S E R V I C E      B U L L E T I N

GAME: Gun Fight Cocktail Table

SUBJECT: Distorted video caused by rear door fan motor magnetic field.

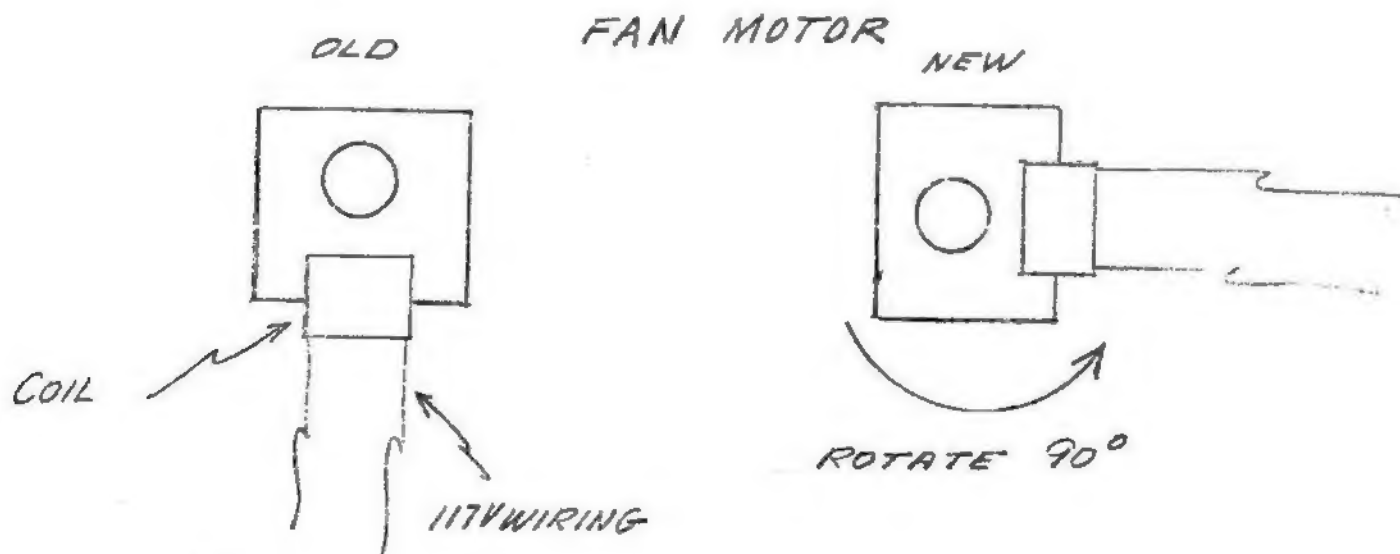
MODIFICATION: Alter mounting of rear door fan motor by rotating the assembly 90 degrees, as shown below.
